ATTACHMENT 2

PROPOSED TECHNICAL SPECIFICATIONS CHANGES  
NORTH ANNA UNITS 1 AND 2

VIRGINIA ELECTRIC AND POWER COMPANY

Figure 3.4-2 — North Anna Unit 1  
 Reactor Coolant System Heatup Limitations

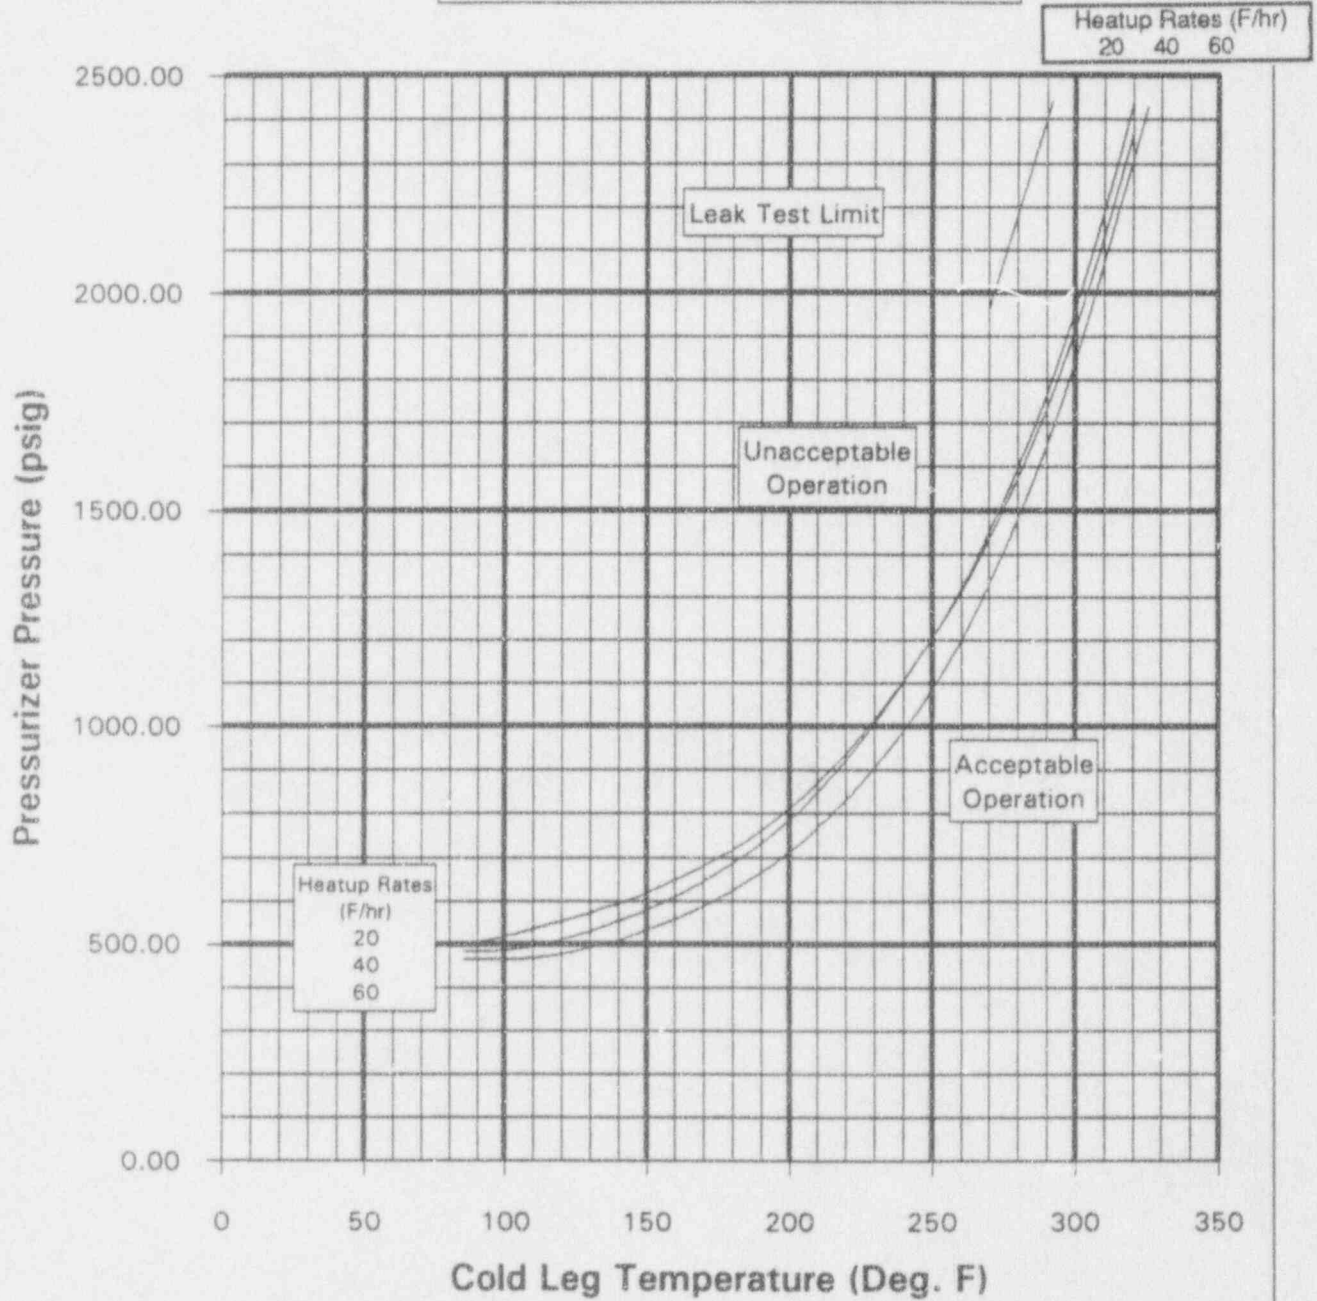
Material Property Basis  
 Limiting Material: Circumferential Weld Seam  
 Limiting ART at 30.7 EFPY: 1/4-T, 162.9 F  
 3/4-T, 139.9

North Anna Unit 1 Reactor Coolant System Heatup Limitations (Heatup Rates up to 60 F/hr) Applicable for the First 30.7 EFPY (Without Margins for Instrumentation Errors)

The heatup limit curve, Figure 3.4-2, is a composite curve which was prepared by determining the most conservative case, with either the inside or outside wall controlling, for any heatup rate up to 60°F per hour. The cooldown limit curves of Figure 3.4-3 are composite curves which were prepared based upon the same type analysis with the exception that the controlling location is always the inside wall where the cooldown thermal gradients tend to produce tensile stresses while producing compressive stresses at the outside wall. The heatup and cooldown curves were prepared based upon the most limiting value of the predicted adjusted reference temperature at the end of 30.7 EFPY. The most recent capsule analysis results are documented in Westinghouse Report WCAP-11777, February 1988. The heatup and cooldown curves are documented in Westinghouse Report WCAP-13831, Rev. 1, August 1993.

The pressure-temperature limit lines shown on Figure 3.4-2 for inservice leak and hydrostatic testing have been provided to assure compliance with the minimum temperature requirements of Appendix G to 10 CFR 50. The minimum temperature for criticality specified in T.S. 3.1.1.5 assures compliance with the criticality limits of 10 CFR 50 Appendix G.

Figure 3.4-3 — North Anna Unit 1  
 Reactor Coolant System Cooldown Limitations

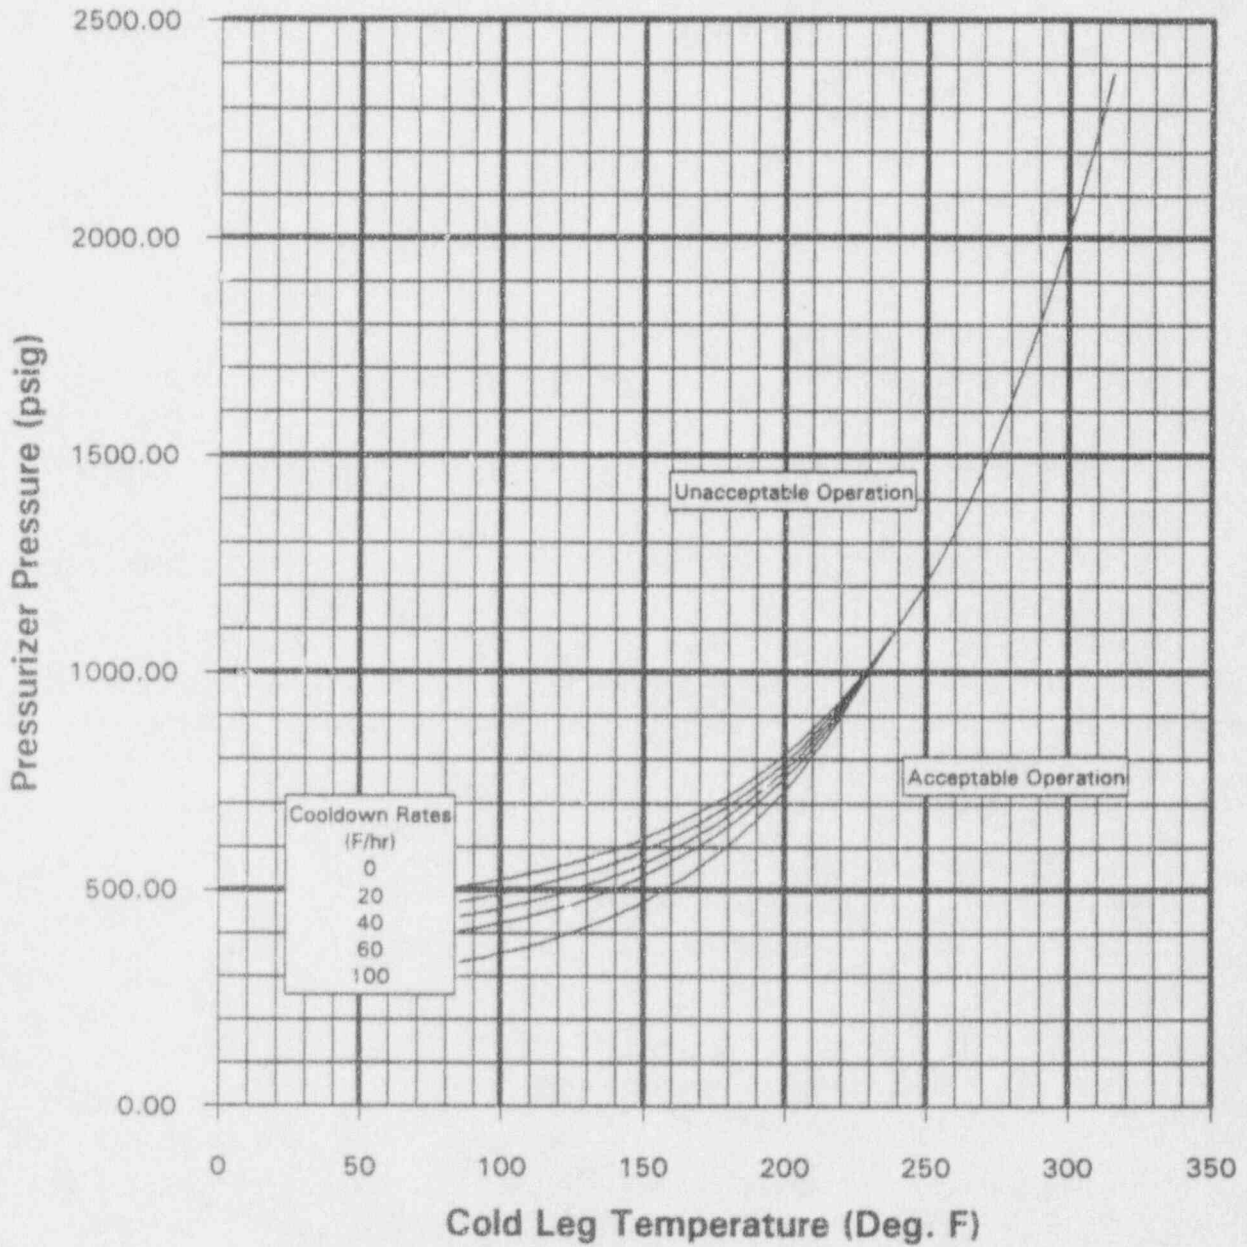
Material Property Basis  
 Limiting Material: Circumferential Weld Seam  
 Limiting ART at 30.7 EFPY: 1/4-T, 162.9 F  
 3/4-T, 139.9 F

North Anna Unit 1 Reactor Coolant System Cooldown Limitations (Cooldown Rates up to 100 F/hr) Applicable for the First 30.7 EFPY (Without Margins for Instrumentation Errors)

Figure 3.4-2 — North Anna Unit 2  
 Reactor Coolant System Heatup Limitations

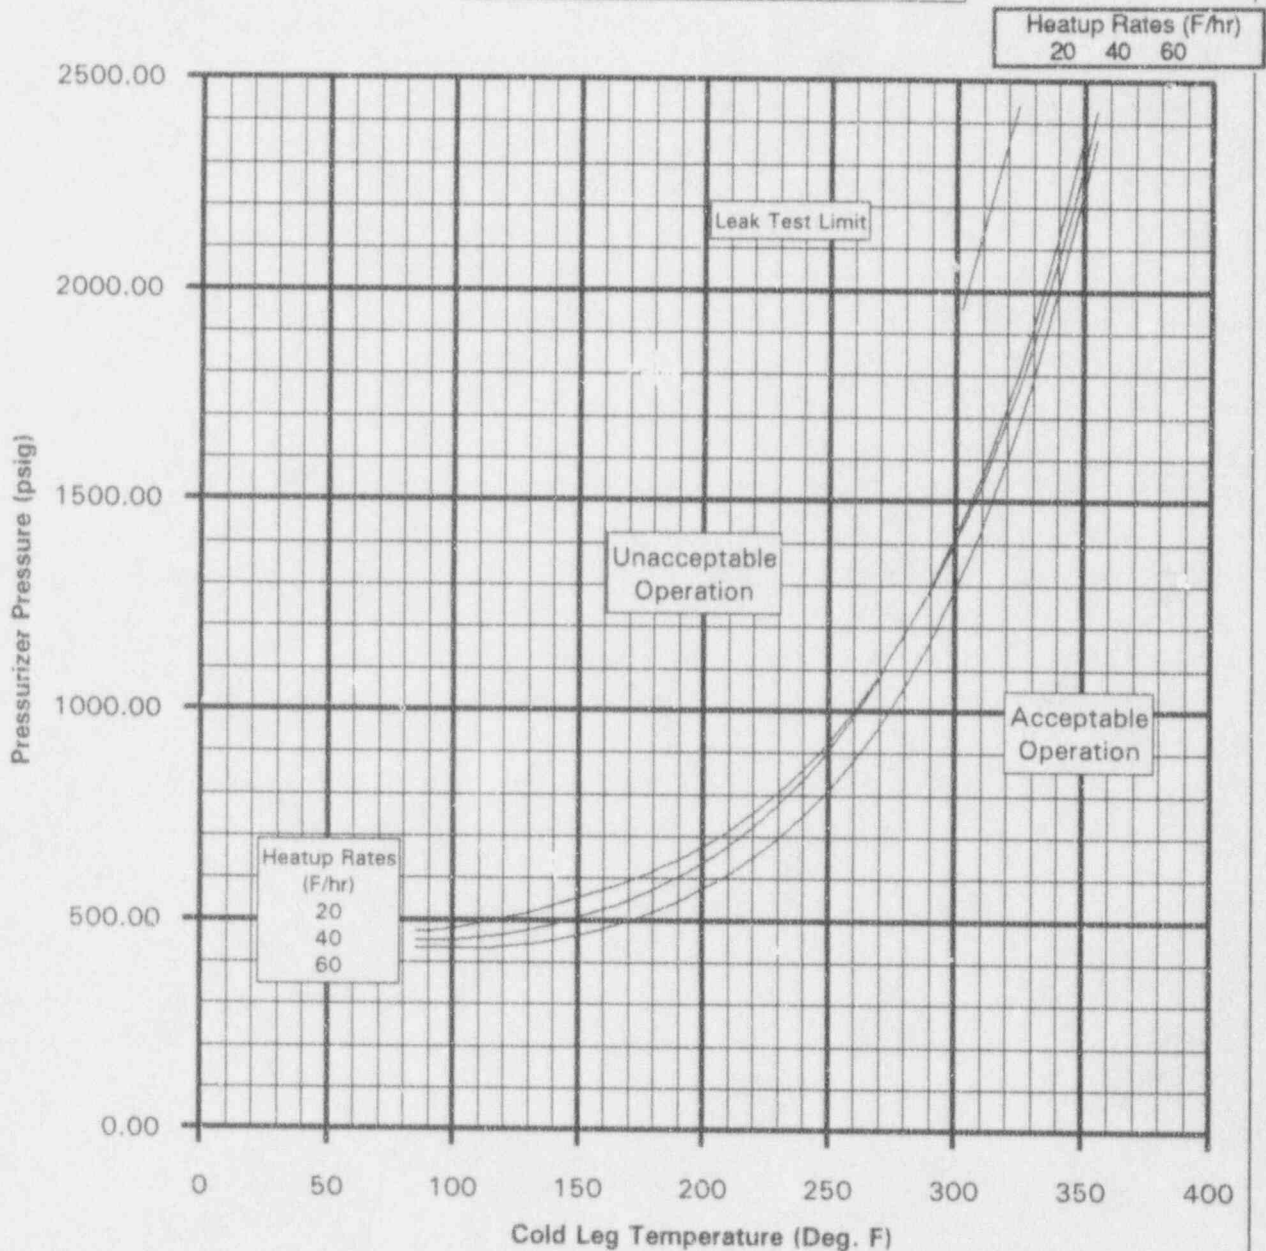
Material Property Basis  
 Limiting Material: Lower Shell Plate  
 Limiting ART at 17 EFPY: 1/4-T, 196 F  
 3/4-T, 172 F

North Anna Unit 2 Reactor Coolant System Heatup Limitations (Heatup Rates up to 60 F/hr) Applicable for the First 17 EFPY (Without Margins for Instrumentation Errors)

The heatup limit curve, Figure 3.4-2, is a composite curve which was prepared by determining the most conservative case, with either the inside or outside wall controlling, for any heatup rate up to 60°F per hour. The cooldown limit curves of Figure 3.4-3 are composite curves which were prepared based upon the same type analysis with the exception that the controlling location is always the inside wall where the cooldown thermal gradients tend to produce tensile stresses while producing compressive stresses at the outside wall. The heatup and cooldown curves were prepared based upon the most limiting value of the predicted adjusted reference temperature at the end of 17 EFY. The most recent capsule analysis results are documented in Westinghouse Reports WCAP-12497, January 1990. The heatup and cooldown curves are documented in Westinghouse Report WCAP-12503, March, 1990.

The pressure-temperature limit lines shown on Figure 3.4-2 for inservice leak and hydrostatic testing have been provided to assure compliance with the minimum temperature requirements of Appendix G to 10 CFR 50. The minimum temperature for criticality specified in T.S. 3.1.1.5 assures compliance with the criticality limits of 10 CFR 50 Appendix G.

Figure 3.4-3 — North Anna Unit 2  
 Reactor Coolant System Cooldown Limitations

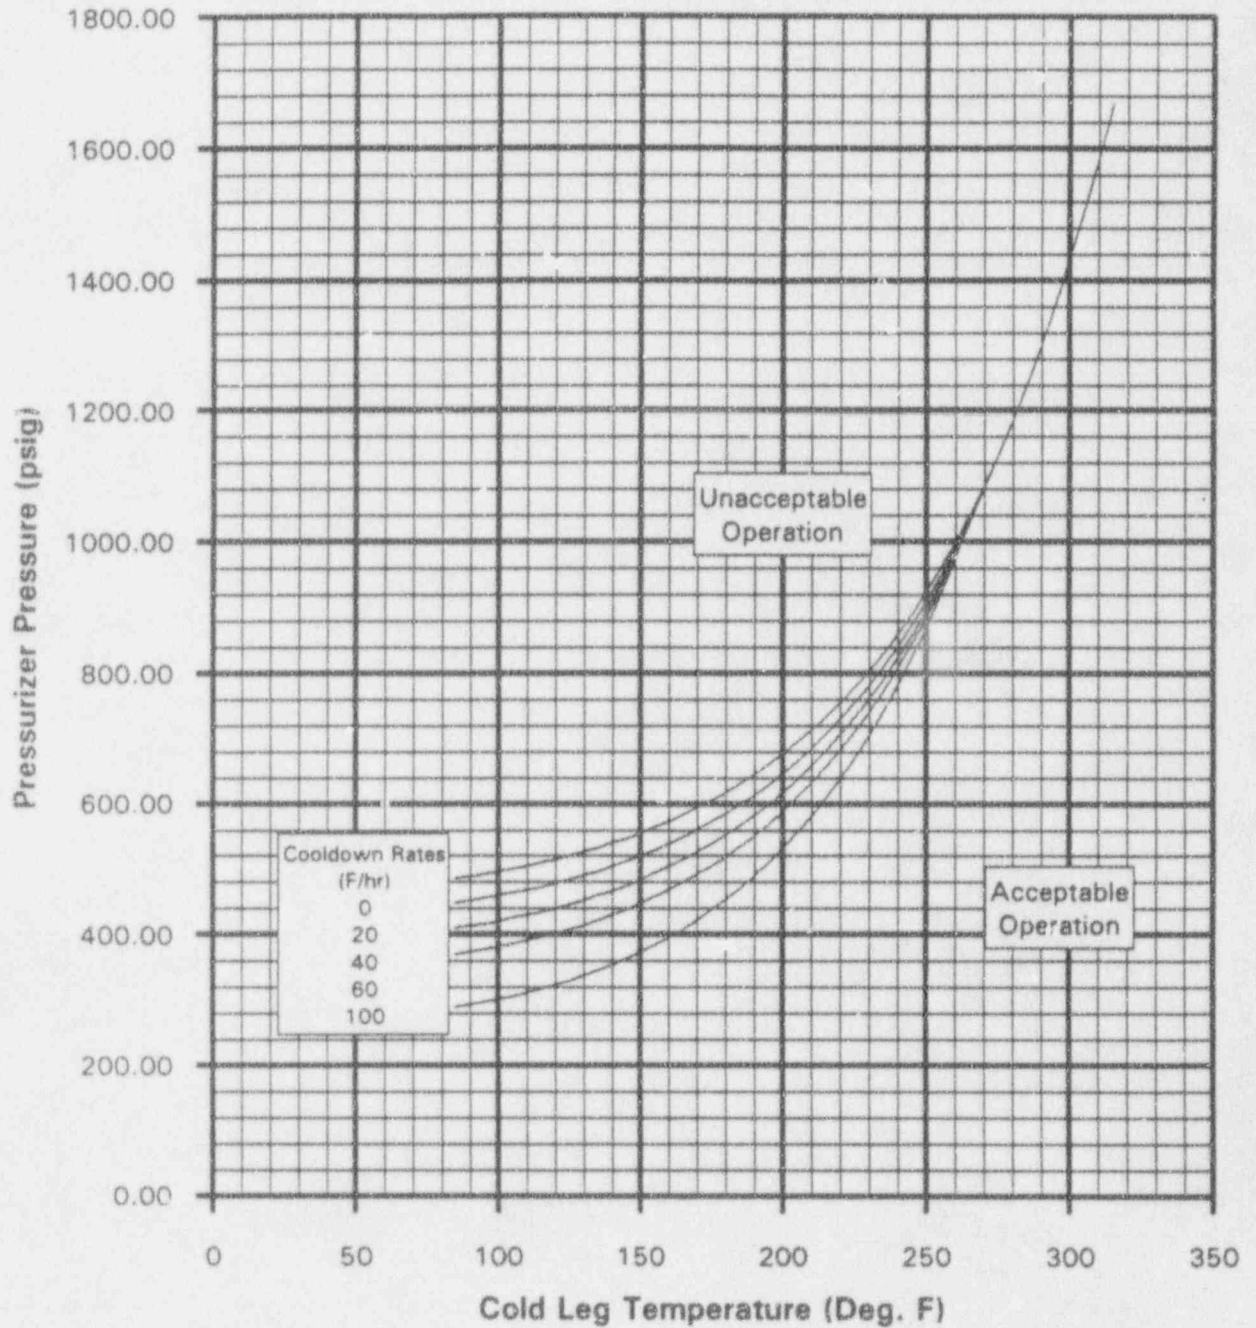
Material Property Basis  
 Limiting Material: Lower Shell Plate  
 Limiting ART at 17 EFPY: 1/4-T, 196 F  
 3/4-T, 172 F

North Anna Unit 2 Reactor Coolant System Cooldown Limitations (Cooldown Rates up to 100 F/hr) Applicable for the First 17 EFPY (Without Margins for Instrumentation Errors)
